UNITED STATES PATENT AND TRADEMARK OFFICE

APPLICATION NO.	FILING DATE	FIRST NAMED INVENTOR	ATTORNEY DOCKET NO.	CONFIRMATION NO.
09/980,295	11/29/2001	Nils Alveby	32207	1433

Office Action Summary

DETAILED ACTION

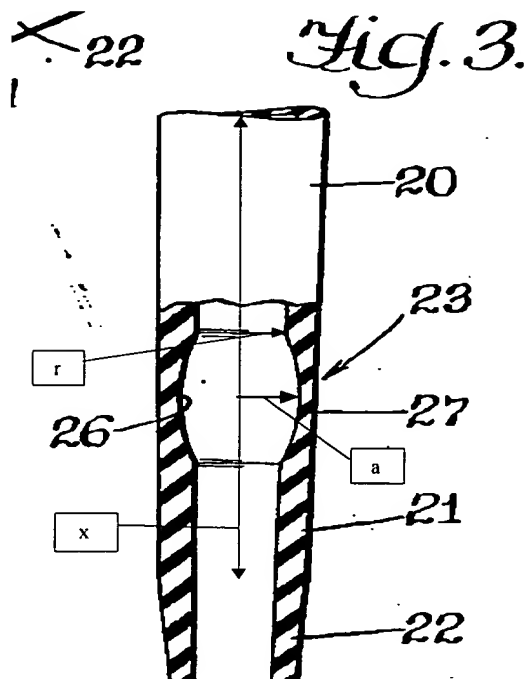
In regards to claim 5, Larson '201 in view of Larson '243 discloses the claimed invention except for the cross-sectional shape of the channel forming a first outward portion including a radius (r) and a second outwardly extending portion. In figure 3 below, Hein teaches the cross-sectional shape of the channel forming a first outward portion including a radius (r) and a second outwardly extending portion "to provide an improved milker" (col. 1, line 78). It would have been obvious to one having ordinary skill in the art at the time the invention was made to fabricate the cross-sectional shape of the channel with a first outward portion including a radius (r) and a second outwardly extending portion to provide an improved milker, as taught by Hein.

In regards to claim 8, in figure 3 above, Hein discloses the channel having a longitudinal center axis (x), wherein a distance (a) between the second portion and the center axis (x) is larger than the radius (r) seen in a cross-section through the transition portion.
